Ordinary Meeting of Council

Thursday 28 April 2022

6.17	Development Application No DA200273 - 66 Lot Community Title Subdivision - 2090 Sutton Road, Sutton	
	Attachment A. Locality Plan.....	3
	Attachment B. Zoning and Minimum Lot Size Map.....	4
	Attachment C. Subdivision Plans - General Layout	5
	Attachment D. Subdivision Plan - Lot Sizes.....	7
	Attachment E. Submissions.....	10
	Attachment F. Applicant's response to submissions	30
	Attachment G. Department of Planning & Environment Recommendation Report.....	68
	Attachment H. Referral Responses.....	114
	Attachment I. Biodiversity Certification Map.....	132
	Attachment J. Section 4.15 Assessment.....	133
	Attachment K. Landscaping Plan	155
	Attachment L. Draft conditions of consent.....	156
6.18	Walker Park Grandstand - Public Exhibition Outcomes	
	Attachment A. Walker Park Grandstand Submission	190

Comment on DA 200273 at 2090 Sutton Road

6.1 Development Application No DA200273 - 66 Lot Community Title Subdivision - 2090 Sutton Road, Sutton
Attachment C Subdivision Plans - General Layout

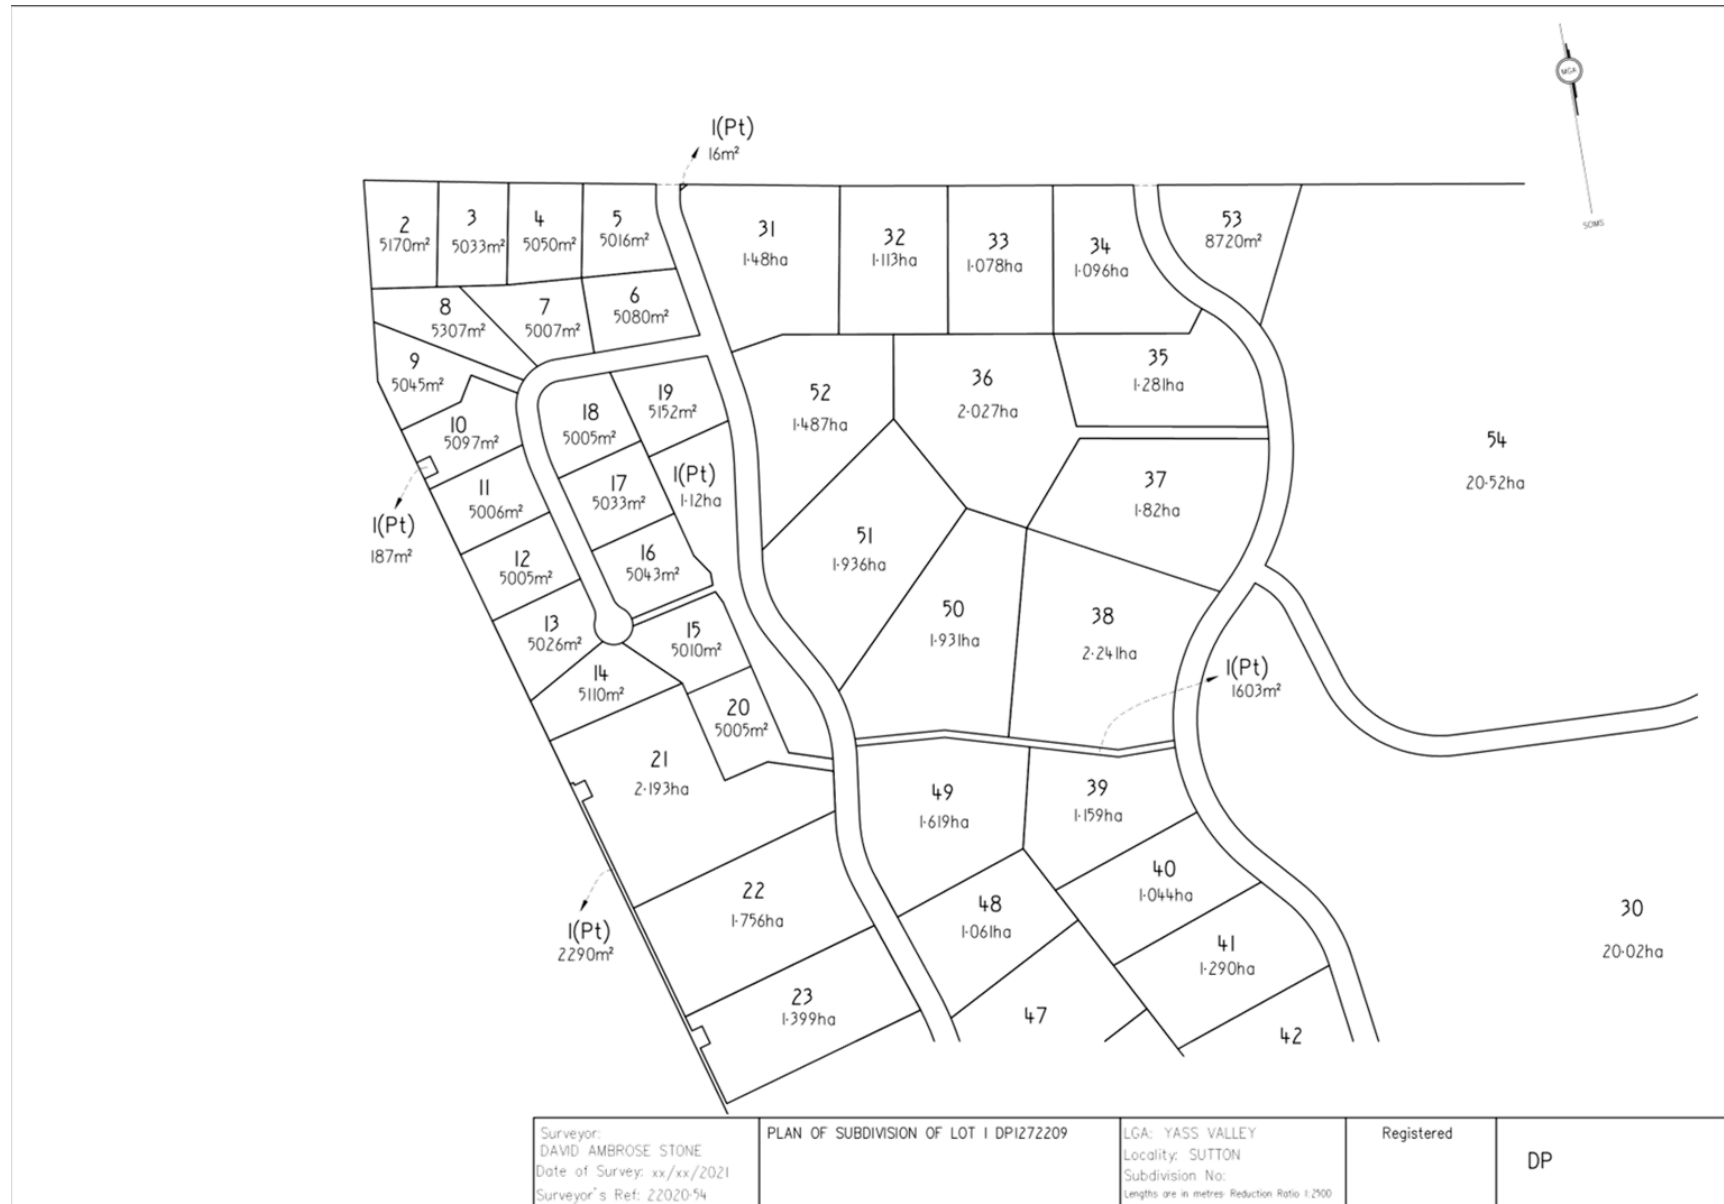
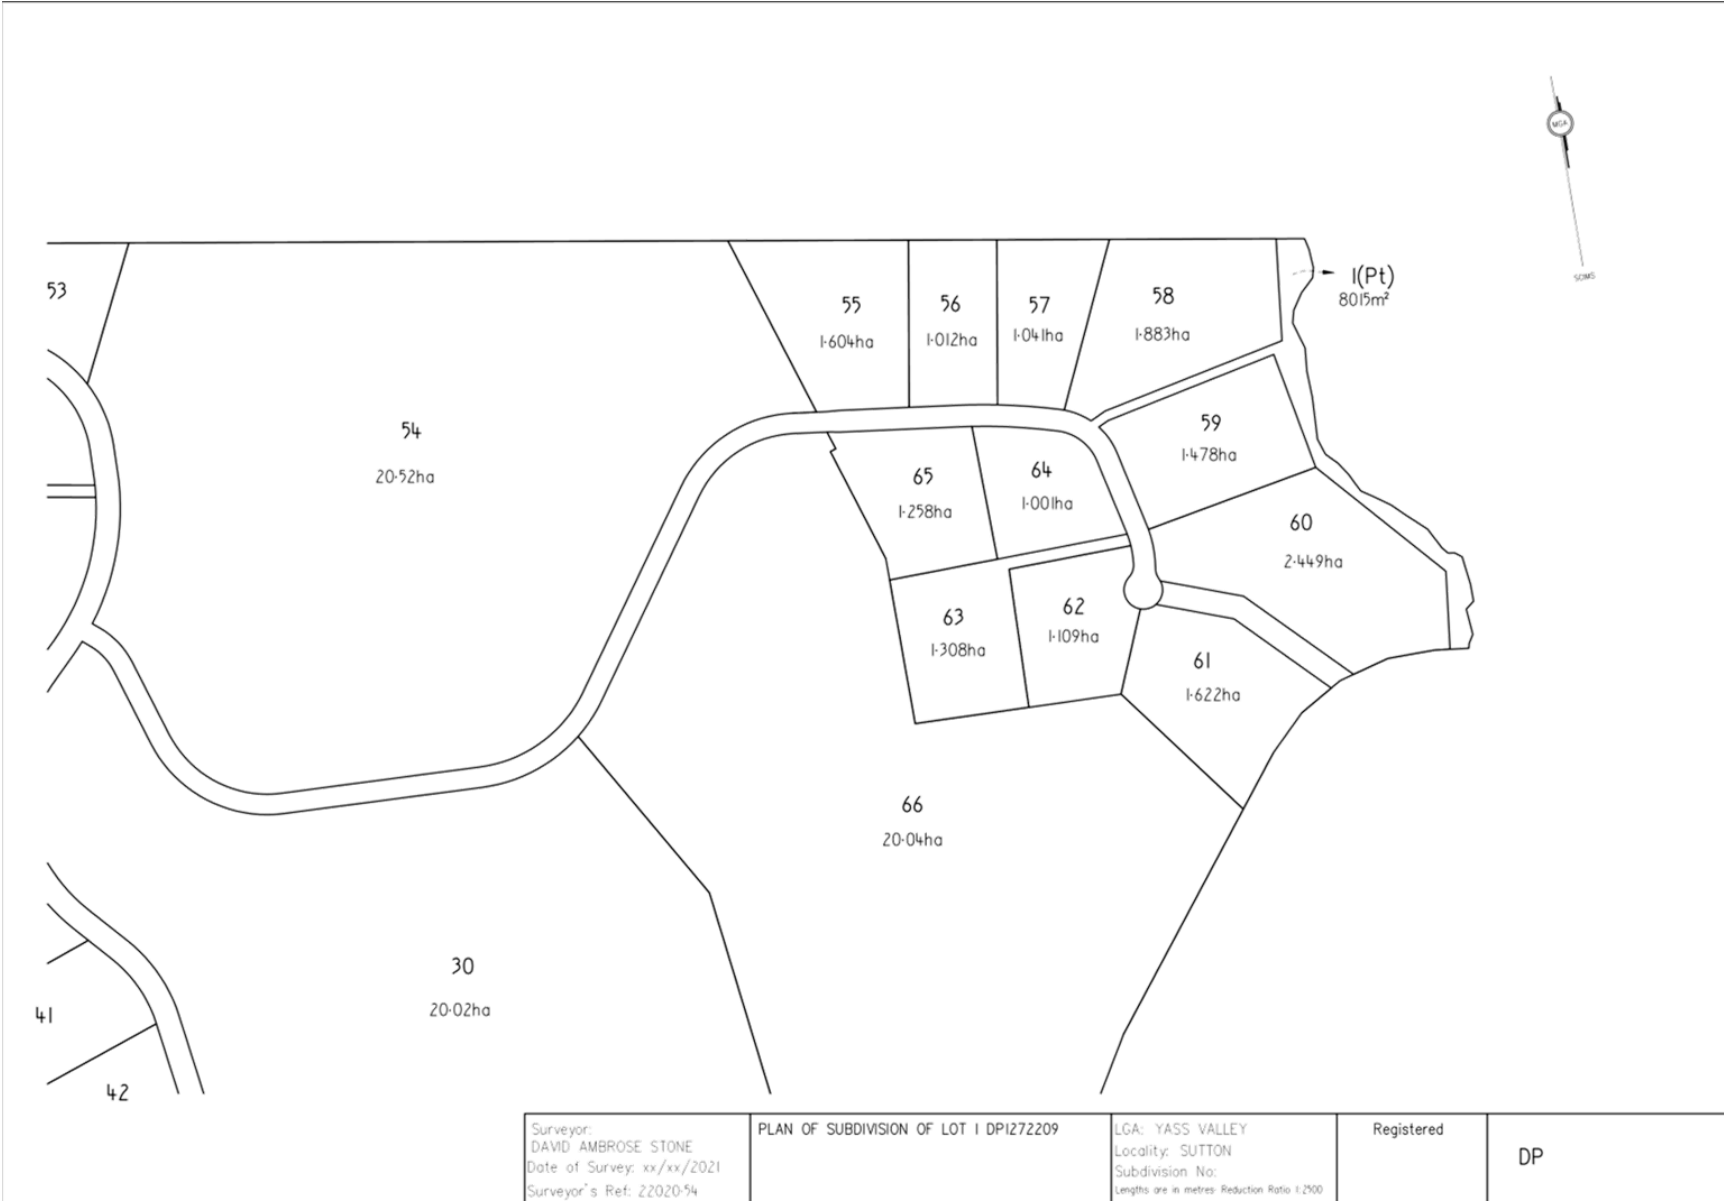
The development proposal identifies a “10 metre wide landscape easement” along part of the Sutton road boundary, however this appears to be on the individual lots. This should be on common land so that community and Council have control over the management and maintenance of this easement. This easement should be planted and maintained for a suitable period by the developer at the time of constructing the subdivision.

The subdivision layout should be amended to remove the 10 metre wide planting easement from the private lots.

The Master Plan map specifically indicates a “link to existing village” at Moorong St. This is not in the proposed development subdivision. Moorong St should be continued south into the development area.

The current subdivision layout includes a number of dead end roads. These are undesirable from the perspective of pedestrian and vehicle permeability and also do not meet the requirements for planning for bush fire protection.

The proposed subdivision road layout should not be approved with no-through roads exceeding 200 metres in length. The road network should be redesigned taking into account the comments arising from the Sutton Master Plan at 2.2 and 2.6 above.

The plans identify a stormwater treatment pond in the public park area, however it is unclear whether this would treat all the stormwater runoff from the site entering Mclaughlins Creek. If treatment of stormwater is indeed required it should include all affected runoff.

Based on our response to the matters raised in the public submissions, we believe that the development as proposed should remain unchanged to that as originally submitted to Council as part of the current DA. Notwithstanding, the Proponent would be willing to work with Council to accept suitably worded consent conditions in relation to the following (only as deemed to be strictly required):

- The provision of a landscaping strip for planting and establishment of suitable endemic species within the Sutton Road verge adjoining the proposed RUS Village lots.

ATTACHMENT 1 – Concept Development Scheme (Planning Proposal) and Subdivision Layout Plan (Current DA)

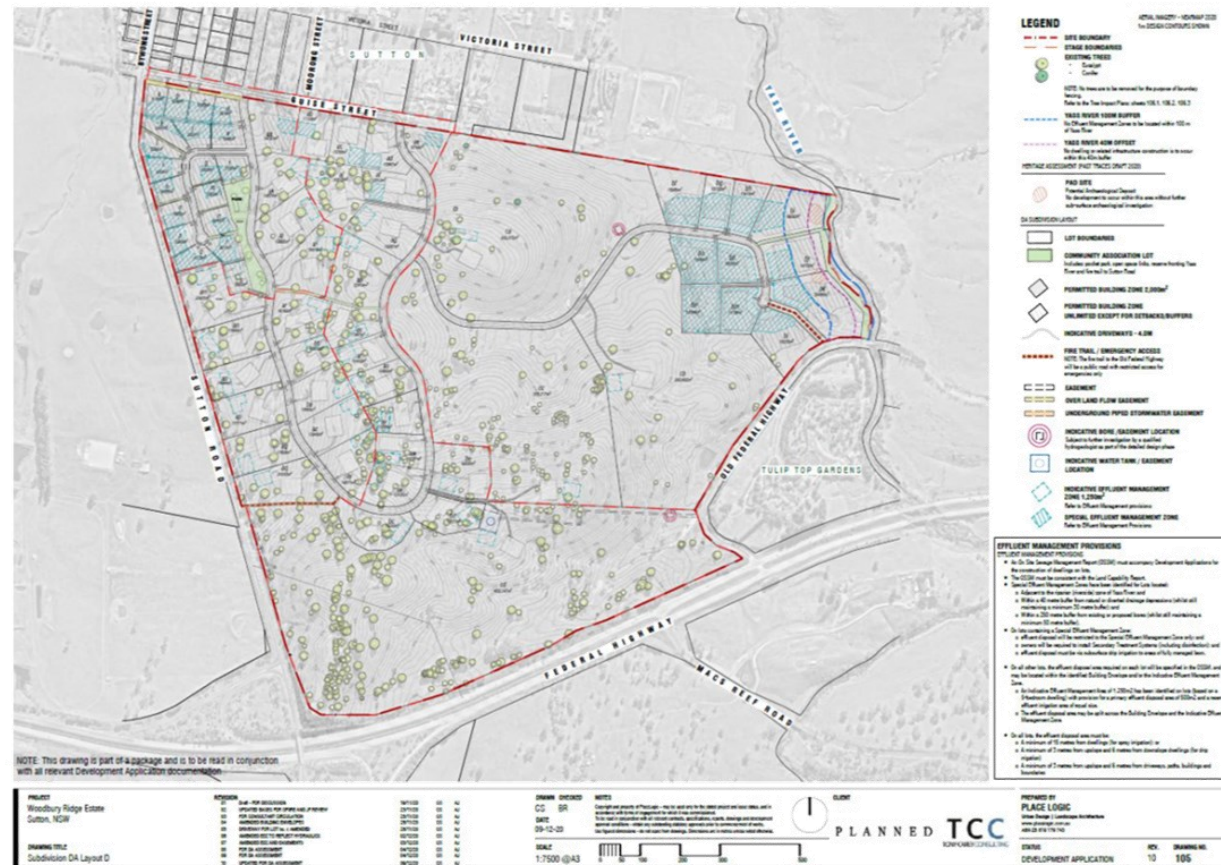
Based on our review of the submissions received, there is a common theme that the development proposed may be inconsistent with specific directions and goals of the Yass Valley Settlement Strategy and the Sutton Village Master Plan.

It is to be noted that the Settlement Strategy and Master Plan were addressed as part of the Planning Proposal for this land that included a conceptual development scheme for the site, which is not too dissimilar to the subdivision layout plan submitted to Yass Valley Council as part of this current Development Application (DA). A copy of the concept development scheme and current subdivision layout plan are included at **Attachment 1** to assist you in appreciating the similarities.
